Technical Service Bulletin

Reference: ICOM-TSB15-002	Date: 5/8/2015
-------------------------------------	--------------------------

Vehicle Will Not Switch Over to Propane

New installations of the JTG II Bi Fuel Liquid Propane System

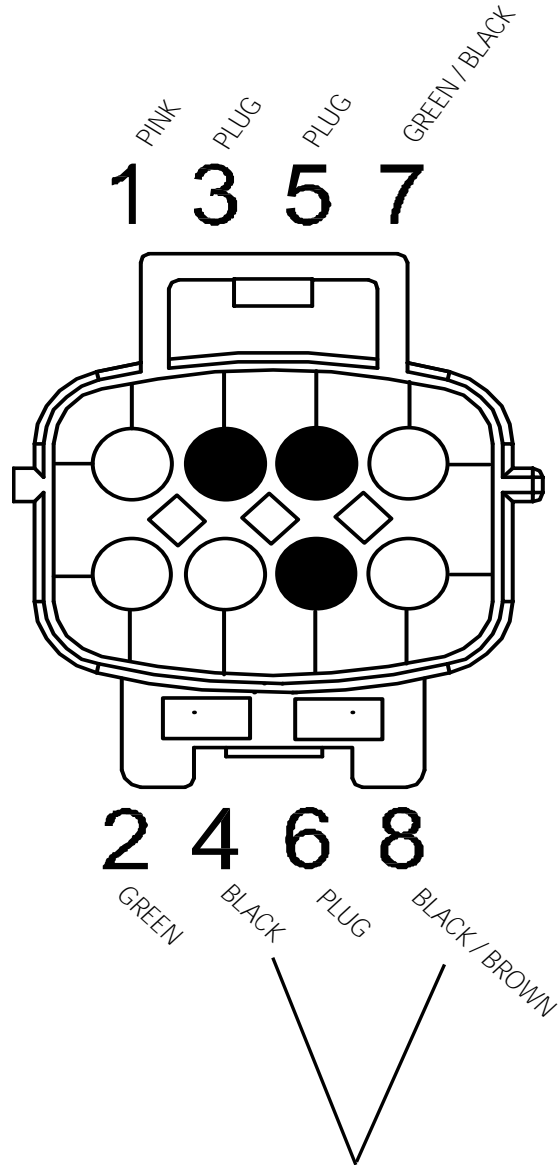
Verify that the black wire and the black/brown wire on the fuel tank wire harness are assembled into the 8-pin connector correctly (see Attachment 'A'). The black/brown wire is a 'switched ground' circuit and will cause a signal interruption to the supply pressure switch resulting in the 'beep out' condition.

WHEN LOOKING AT THE BACK OF THE FUEL TANK WIRE HARNESS CONNECTOR, VERIFY THAT THE BLACK WIRE IS ASSEMBLED INTO POSITION '4' AND THE BLACK WIRE WITH BROWN TRACER IS INSTALLED INTO POSITION '8' REPOSITION IF NECESSARY
